DCN No. E990258

DOCUMENT CHANGE NOTICE (DCN)

DOCUMENT No. (DOC-REV-GP. ID)	TITLE	NEW REV.
D970550-B-D	GUIDE ROD FIXTURE, BEAMSPLITTER OPTICS	C

APPROVALS	DATE	PROJECT
APPROVED BY: J. Smith	8/98	LIGO CALIFORNIA INSTITUTE OF TECHNOLOGY MASSACHUSETTS INSTITUTE OF TECHNOLOGY
DESIGNED BY: J. Smith		GUIDE ROD FIXTURE BEAMSPLITTER OPTICS
DRAWN BY: J. Smith		0970550
CHECKED BY: J. Smith		REV: 1 OF 1

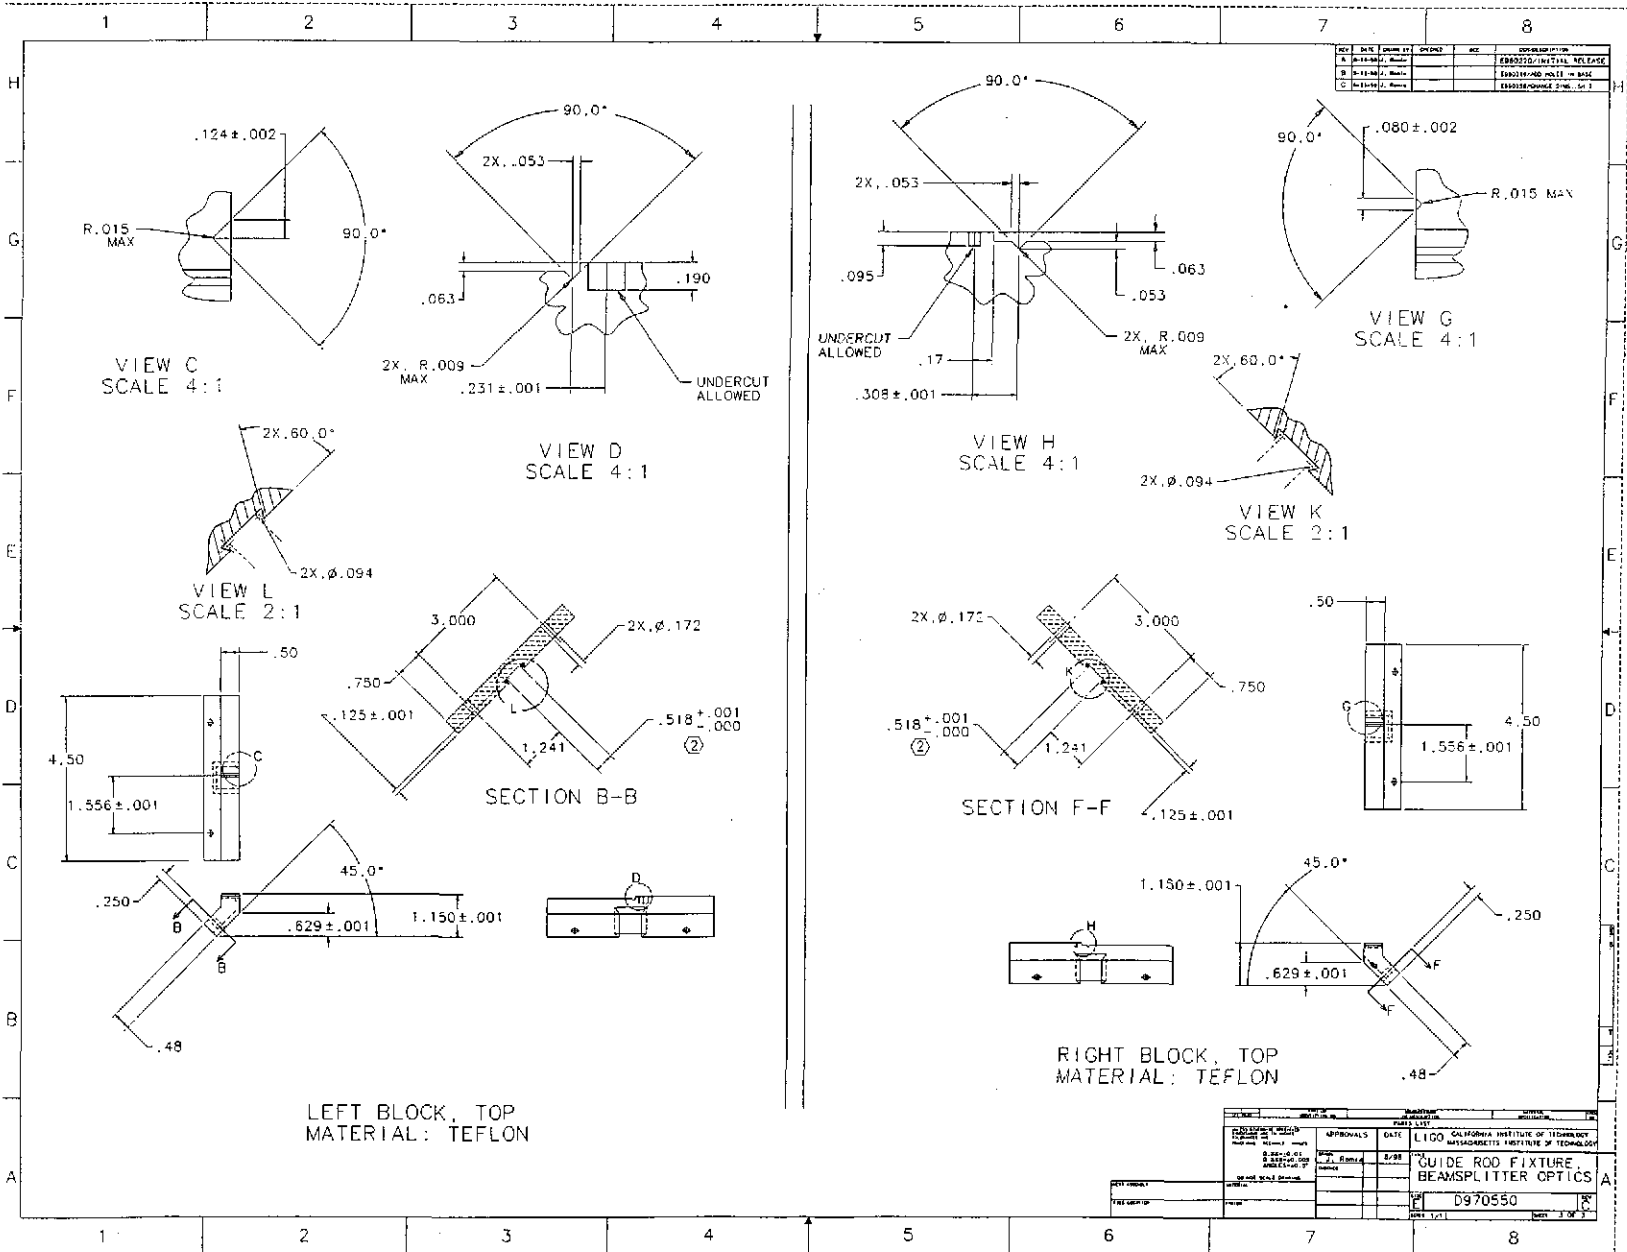
CHANGE DESCRIPTION (FROM/TO): Sheet 2, change dimension 11.778 +/- .001 to 11.481 +/- .001
 Sheet 2, change dimension 5.889 +/- .001 to 5.741 +/- .001
 Sheet 2, change dimension .912 to 2X, .764, remove one .912 dimension.

REASON FOR CHANGE: dimensional error
